From: [Piantka, George](#)
To: ["Murphy/Perkins"](#);
cc: [Laurie B. Jester; kchristensen@elsegundo.org; lyle cripe; Doris Nickelson; Nickelson, Nick; McKinsey, John; Riesz, Ken; Seipel, Scott; Dyas, Mary@Energy; Sisk, Tim;](#)
Subject: RE: El Segundo Energy Center (00-AFC-14C) - Transmittal of VIS-9 Figures Per Conditions 5 and 6 of Joint Statement of Agreement
Date: Sunday, January 27, 2013 12:06:39 PM
Attachments: [PL-GRADING-1-20scale-22x34.pdf](#)
[5408-PL-003.pdf](#)
[5408-PL-007_01.21.13.pdf](#)
[VIS-2 Pallet \(2\).pdf](#)
[5408LCP001 Plant Palette.pdf](#)

Cc: lyle cripe <lylecripe@gmail.com>; Doris Nickelson <dorisnickelson1@verizon.net>; Nickelson, Nick <nicknmf@verizon.net>; Laurie B. Jester <ljester@citymb.info>; kchristensen@elsegundo.org <kchristensen@elsegundo.org>; Dyas, Mary@Energy <Mary.Dyas@energy.ca.gov>; John A. McKinsey <jamckinsey@stoel.com>; Seipel, Scott; Riesz, Ken
Subject: Re: El Segundo Energy Center (00-AFC-14C) - Transmittal of VIS-9 Figures Per Conditions 5 and 6 of Joint Statement of Agreement

EL SEGUNDO ENERGY CENTER
 301 VISTA DEL MAR BOULEVARD
45th STREET BERM
REVISED CONCEPT STUDY

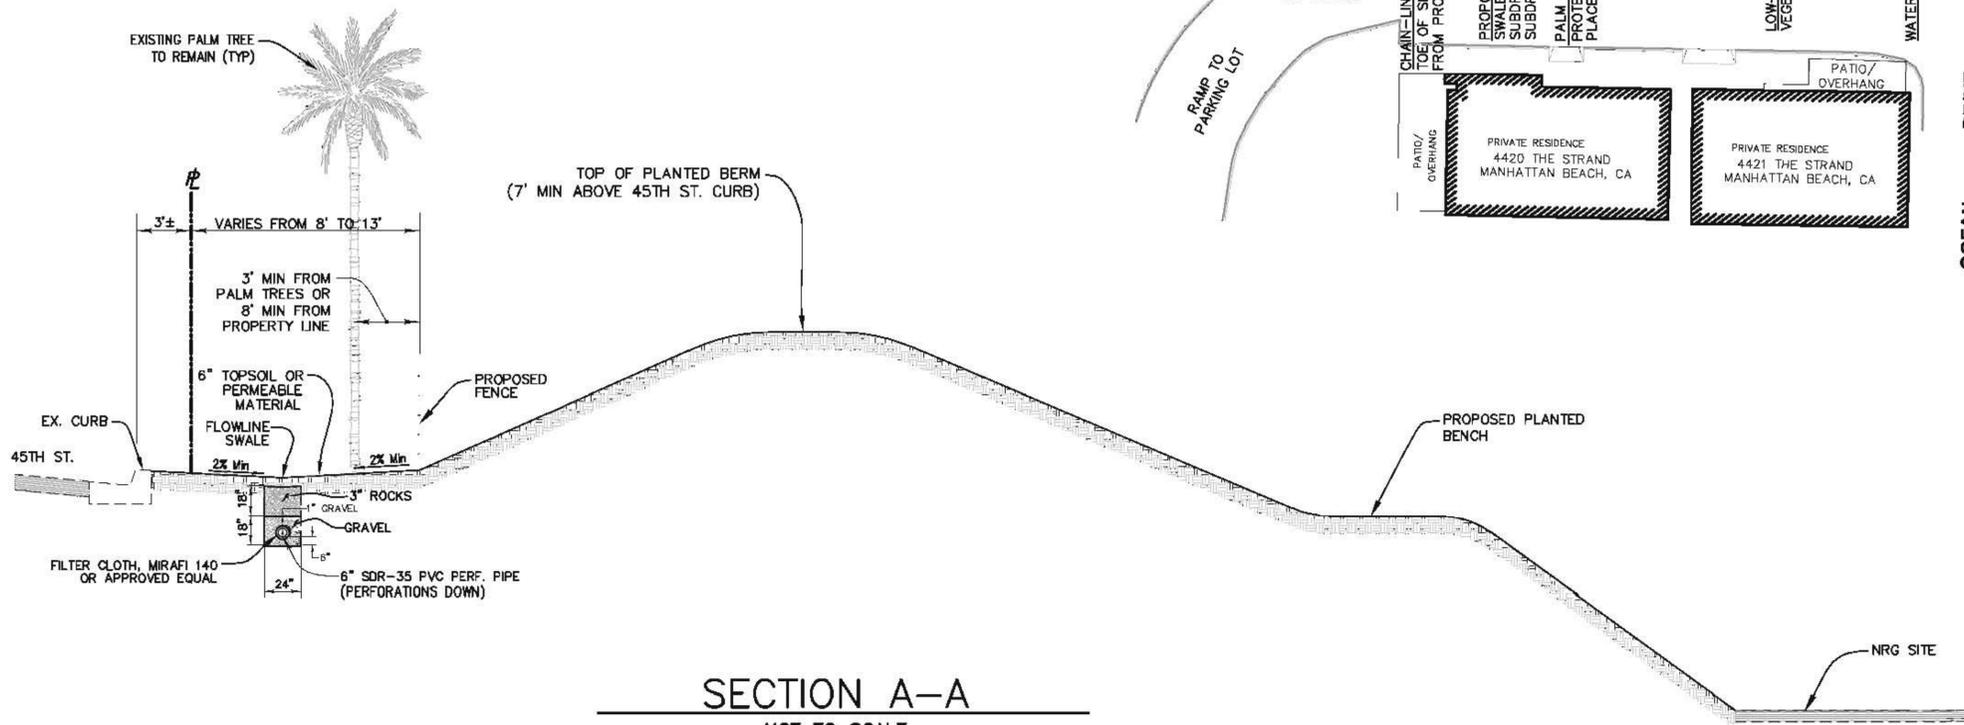
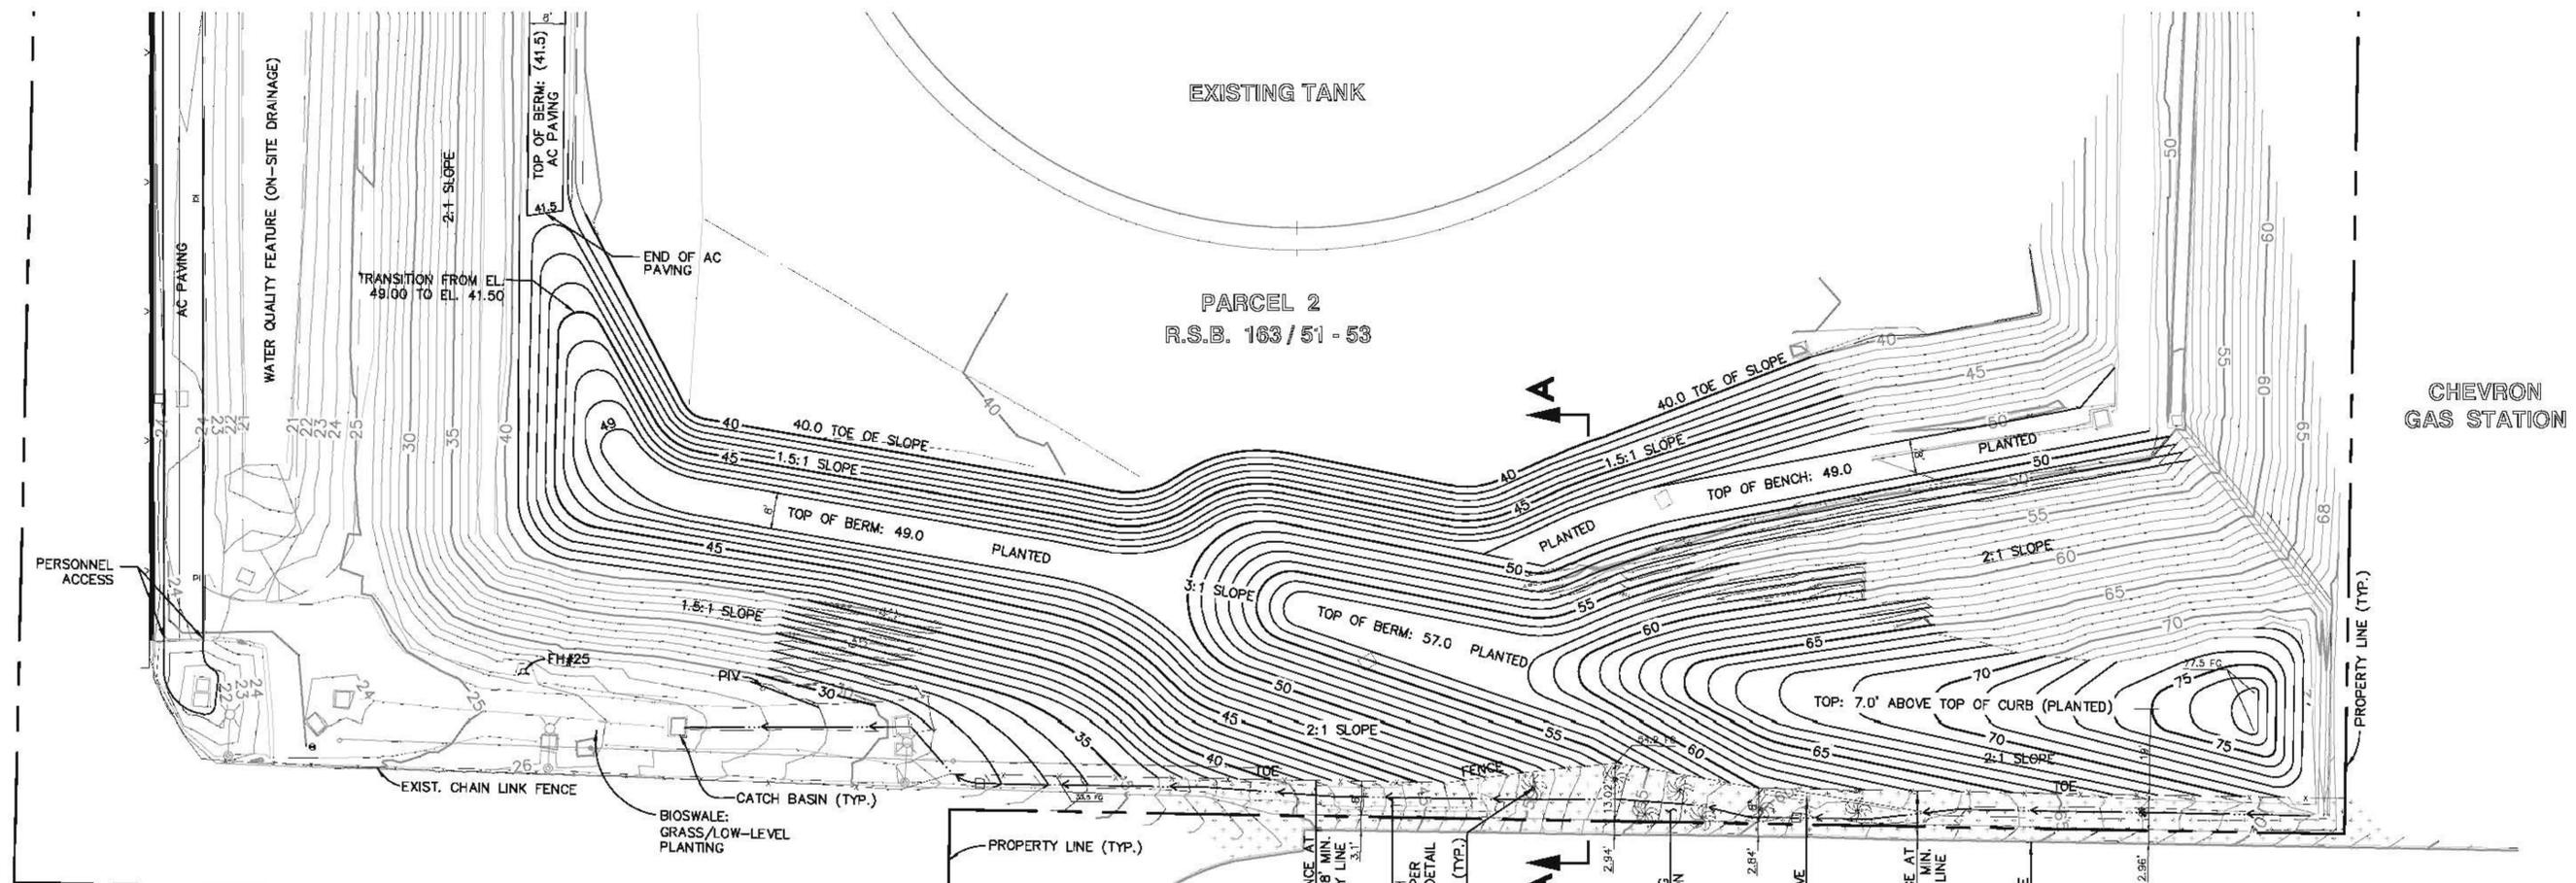
1. Thanks for the clarification. If a 2:1 slope will support the previously intended vegetation, we do not object to steepening the slope in this area to provide a flatter space outside the fence. I do think the words on the drawing should be altered from "chain link fence at toe of slope 8' min from property line" to something that will instruct the contractors to build the fence where it belongs, which is, in this area, more than 8' from the line. Maybe "Chain link fence at toe of slope, on line depicted. Note toe of slope is farther than 8' from property line in this area."? But the important thing is that it be built there, not how you phrase your instructions.

1. We believe the proposed fence line and/or the berm deviate from the Commission's orders and Settlement Agreement in the area west of the palms. In that area, the Agreement's "conceptual sketch" includes a negotiated fence line which is actually both above the toe of the berm and more than 8 feet from the property line, rather than (as on the current "revised concept study", a "Chain link fence at toe of slope 8' min from property line." At all other places "8' min" appears to mean just 8 feet. The Agreement requires more than 8' and above the toe.

2. We are not clear why the currently proposed plans include three flat areas in the berm-- one labeled "bench," on the north downslope, and the other two on the top of the berm at elevations 57.0 and 49.0 feet. We'd like to have that explained before we address whether they are a good idea or not.

3. The "Revised Concept Study" sketch appears to show both a road and "personnel access" in the SW corner of the property. What is intended there? Again, we'd like to learn what's going on before taking a position on this feature of the sketch.

5. We'd like to see the detail for the "proposed swale and subdrain" noted on the Revised Concept Study as being right across from our house, and the "bioswale" near the SW corner of the property. Speaking of the bioswale, is

7. What is the object described as "FM#25" on the Revised Concept Study?

1. Regarding your comments in #1 below – I have attached the applicable figure. The phrase in the figure is accurate; the fence will be a minimum of 8 feet from the property line. But it is the intention to build the fence where depicted on the scaled drawing. The figure shows that substantial portions of the fence are more than 8 feet away from the property line. Your comment reinforces that our communication to the contractors shall be that they build the fence where depicted on the scaled drawing and not seek to place it “a minimum of 8 feet.” I assure you that we will make this very clear to the contractors.

I believe that what you are seeing is actually that we have moved the toe of the slope back (to the north) so that it aligns with the fence and that the fence is still in the same location shown in Attachment A to the JSA. Thus, I think you will find this to be a benefit as it creates more accessible space on the 45th street side of the fence.

The flat area on the north down-slope side is for drainage, stability and erosion control purposes as well as providing a means for walking access in the area for landscape work and other maintenance. There are utilities located under that bench. This bench delineates their (location) and enables access to them for maintenance and repair as needed. The bench is approximately located where the retaining wall had been planned. The area north of

There is a paved path running along the fence line. It has not been compacted or reinforced to sustain heavy vehicles and is not a vehicular road. It is intended to provide a visible and smooth access for lightweight, utility cart-like vehicles to allow access to the fence and to the water quality and water discharge features in that area. Also, the light poles may require access by a scissor-lift, for example, for maintenance/replacement of light bulbs. As noted below, the water quality feature will be planted with low lying vegetation that comes near the edge of the path.

There is a detail for the Swale and Subdrain in the lower left hand area of the revised drawing (Sheet 1). The Swale and Subdrain will be planted with low lying vegetation from the plant palette. This allows water flowing through it during storm events to be partially filtered and slowed as it travels down the slope. Some grasses may be used here, but also groundcover plants.

I think you are referring to the square labeled as FH#25 at foot of slope of berm near SW corner. This is an existing fire hydrant that we are not removing, but rather, preserving in place.

5

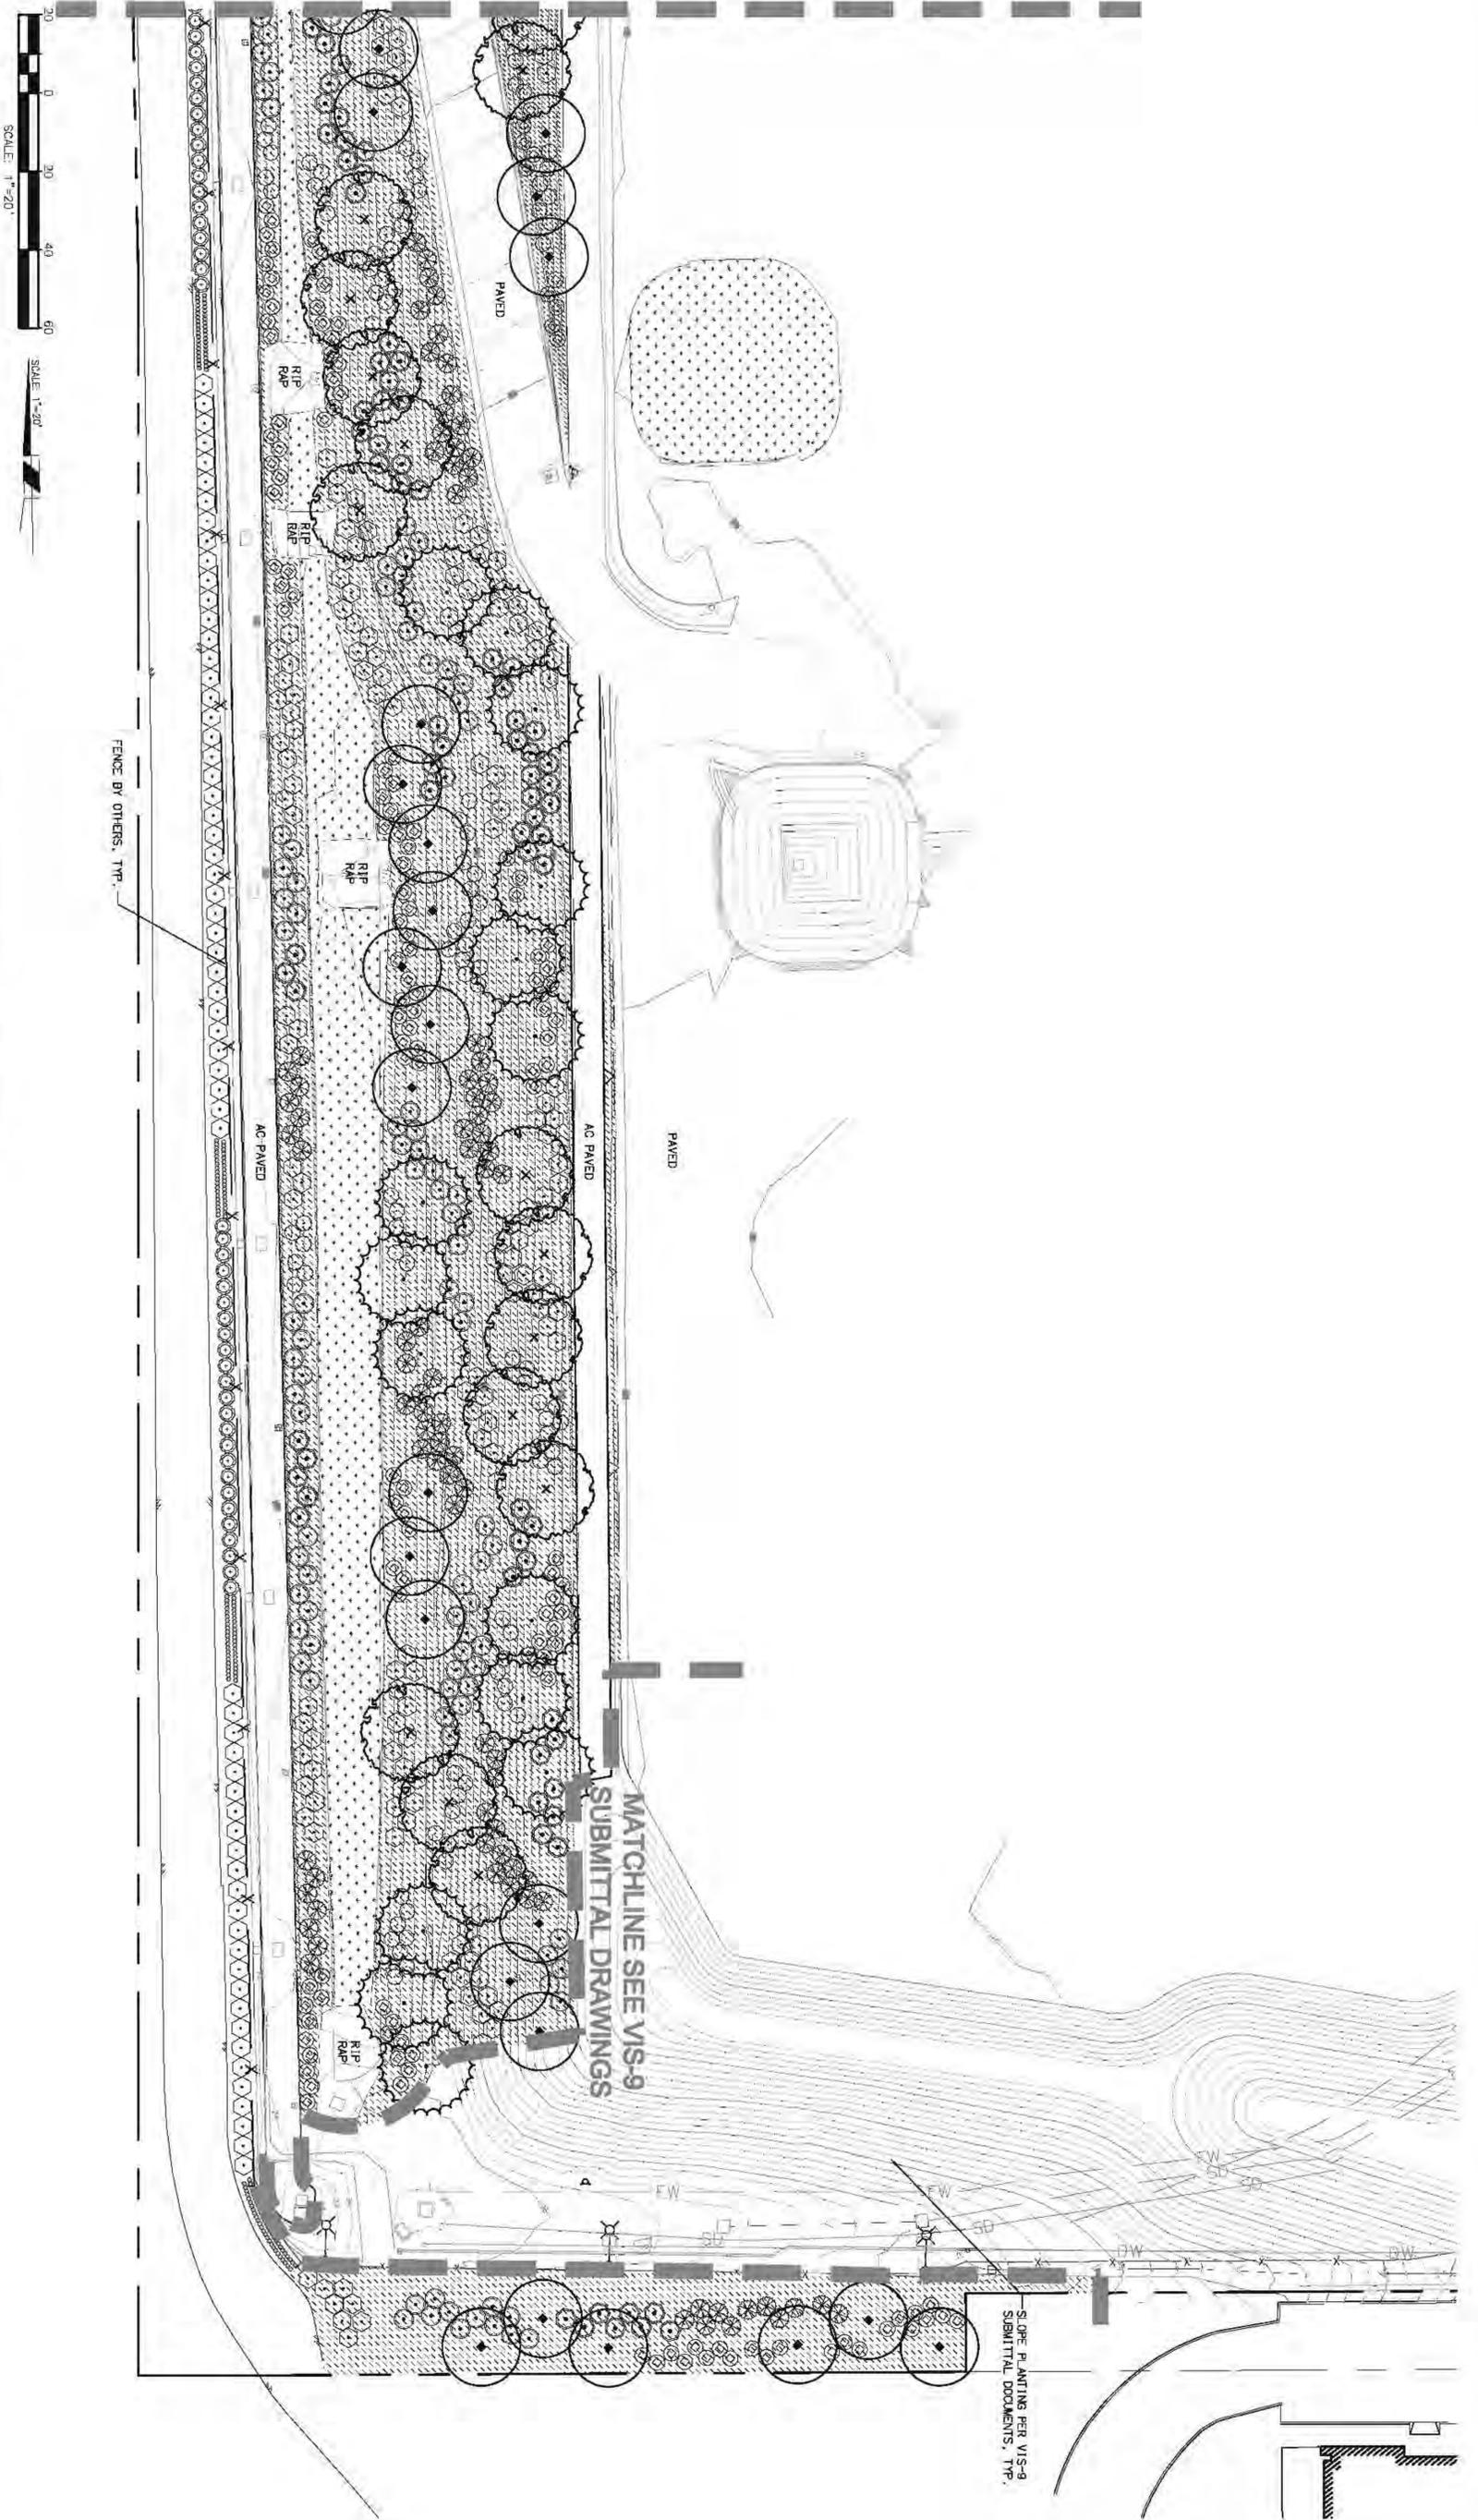
6. Though your description is helpful, is there a drawing of this feature?

6. What is the "water quality feature" along the west boundary of the plant to look like and be constructed of? Dirt? plantings? Concrete?

6. I have enclosed a figure Sheet 5 of VIS-2 that depicts the water quality feature and the planting plan along the western portion of the tank farm berm. This figure matches with Sheet 4 of VIS-9, Appendix A, which was provided earlier per the JSA. Together these figures depict the plans in this portion of the site.

The "water quality feature" is an area designed to accumulate stormwater and allow it to be absorbed; but in significant storm events, it will overflow into the southwest corner discharge point. It will be planted, pursuant to other sheets in the VIS-2 Plan, with low lying vegetation. The vegetation adds further stormwater filtering and improves the quality of any storm water discharge that does overflow into the southwest corner discharge point.
